DATE:	October 19, 2022
TO:	All Bidders
FROM:	Lisa Sorensen, Purchasing Specialist
SUBJECT:	Addendum 1 – RFP 640, Oxnard College Hyflex/Smart Classroom Project

#### Comments and Questions from the 10/18/22 Job-walk

## CHQ.308 – Medium

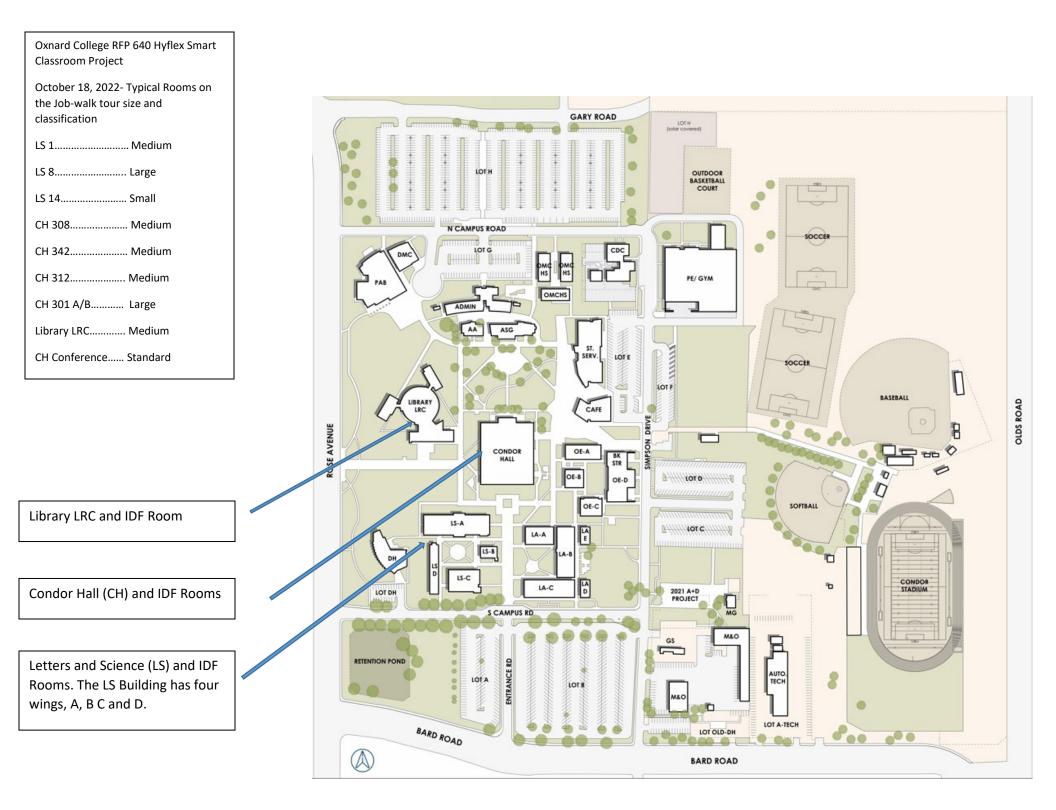
- Q. What is the size of CHQ.308?
- A. Condor hall 308 is a medium sized classroom.
- Q. How many classrooms will be converted ideally?
- A. Depending on budget, Oxnard College hope to install up to 45 rooms, final determination and priority of rooms will be provided the awarded bidder after the final assessment.
- Q. Will drops need to be added for equipment already on the system?
- A. No.
